SUPPLEMENTAL DECLARATION OF RICK W. KENNEDY, ESQ.

Re: Remedial Action Proposal
Tonawanda Coke Corporation

This is in response to your June 15, 2011 letter regarding the ditch remediation at Site 108, also referenced as operable unit (OU) 3.

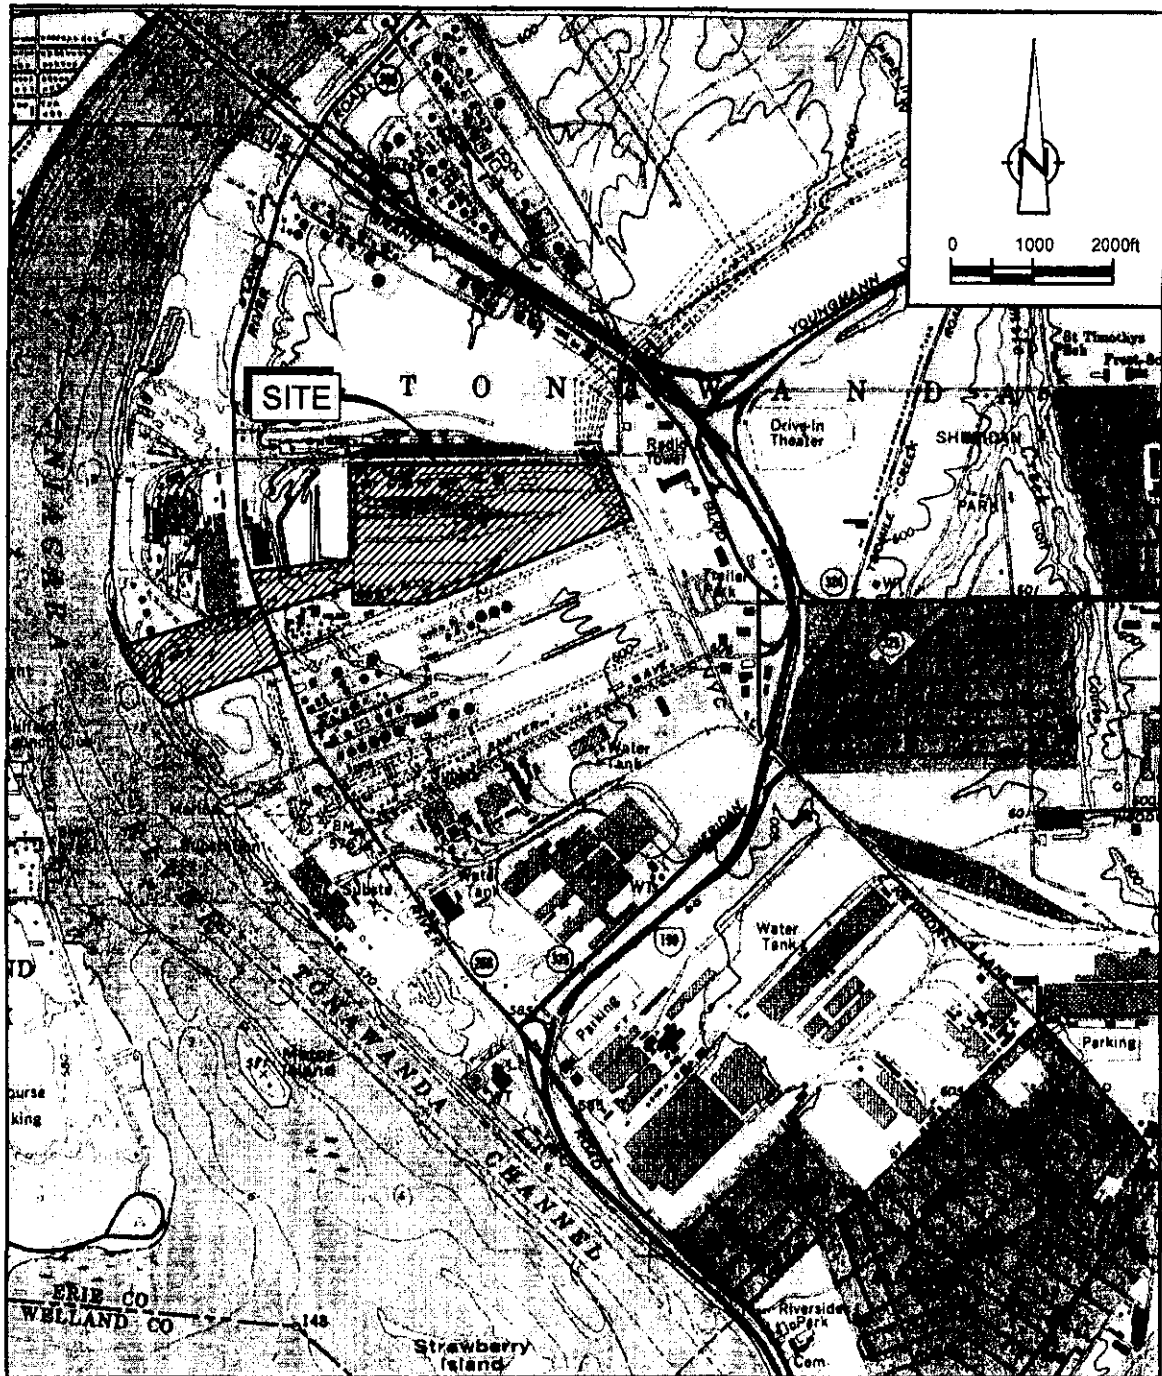
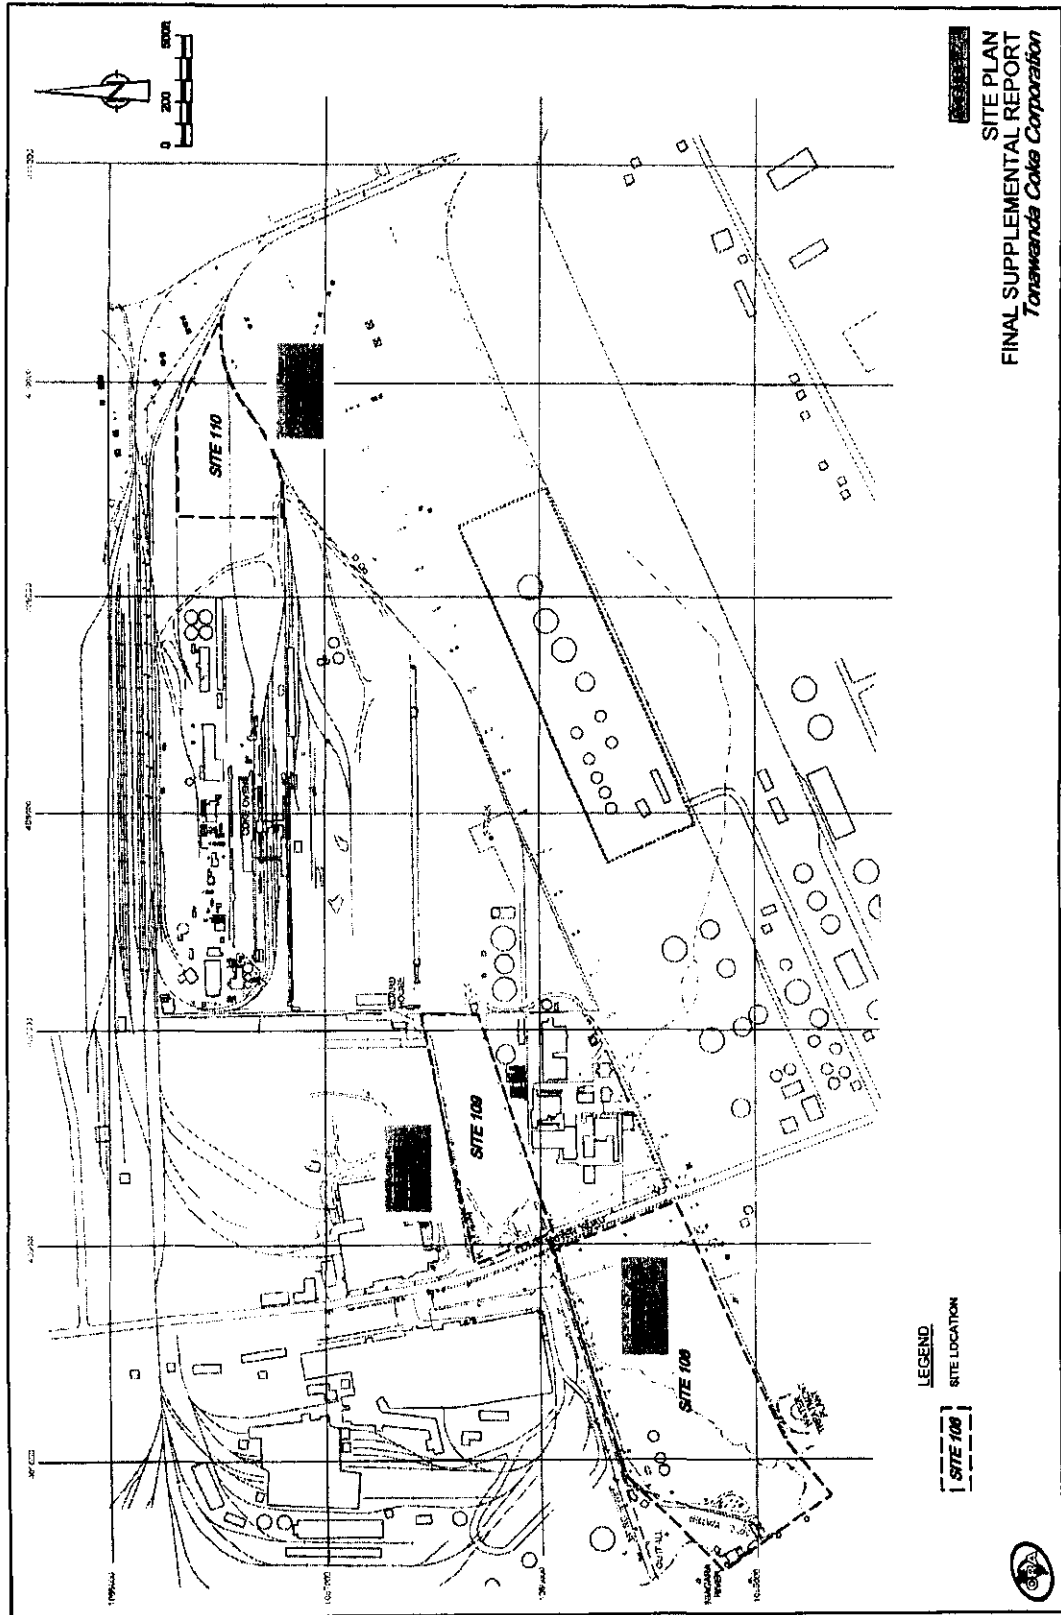
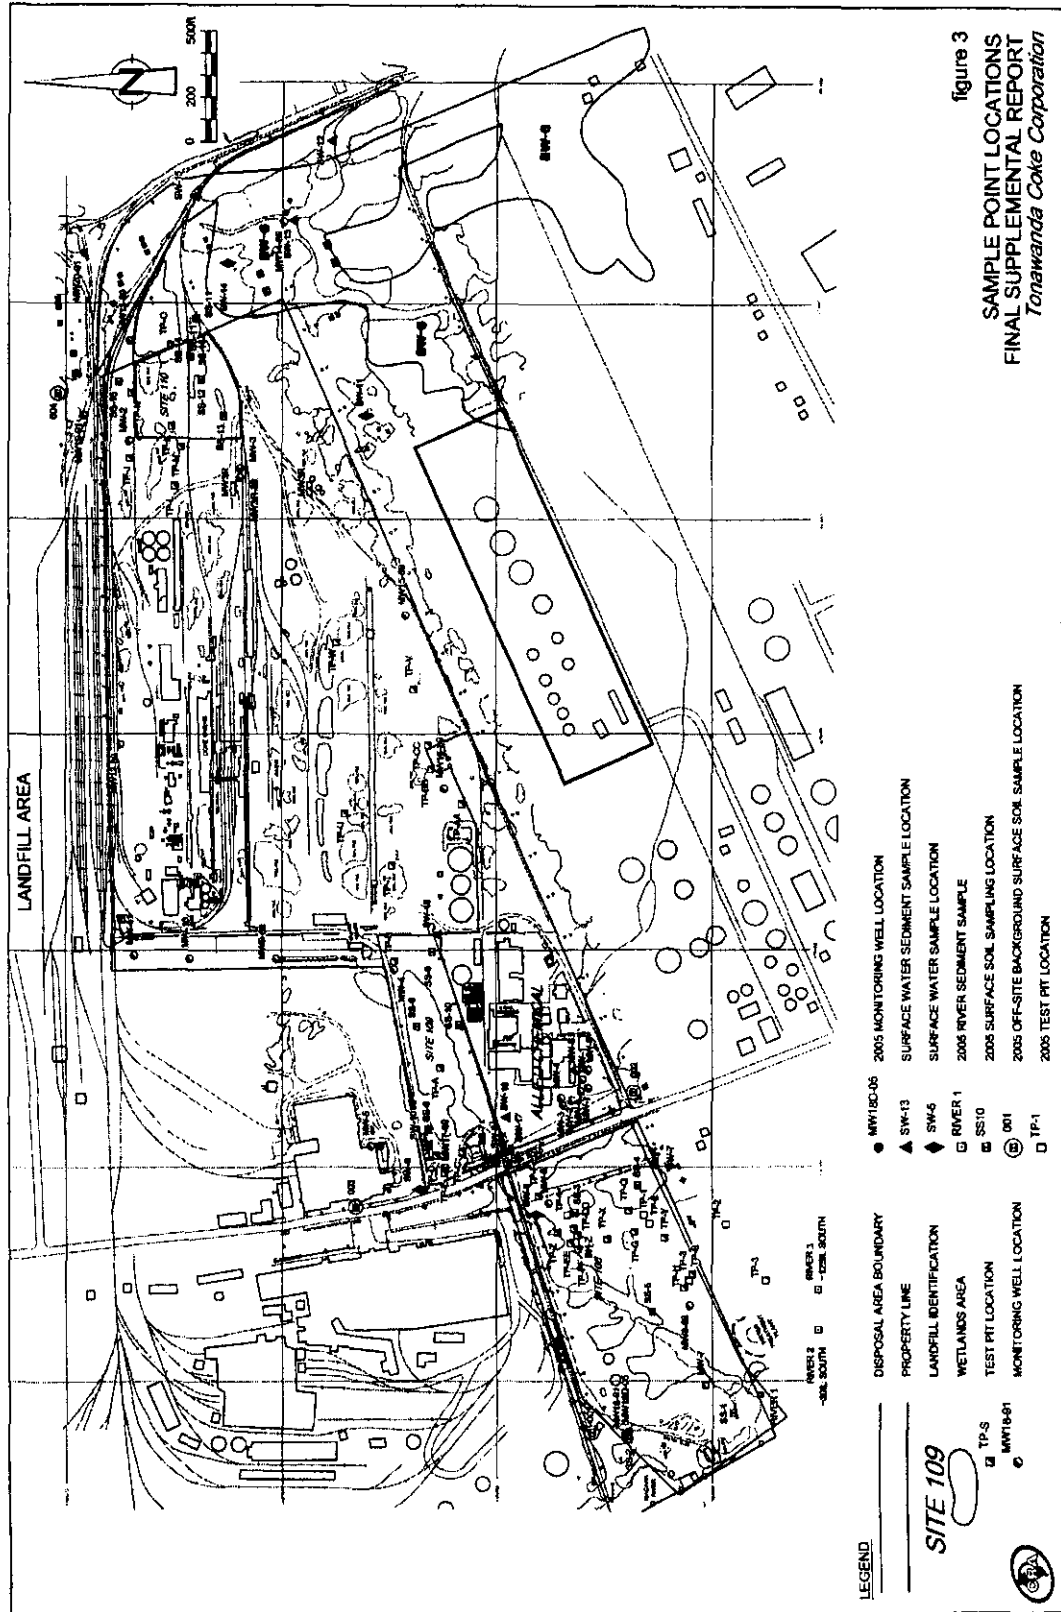
RESPONSE 2:

The investigation was conducted both inside the area of the operable units and outside the operable units. Please refer to Figure 3 of the ROD for the location of soil, groundwater, surface water and sediment sampling locations.
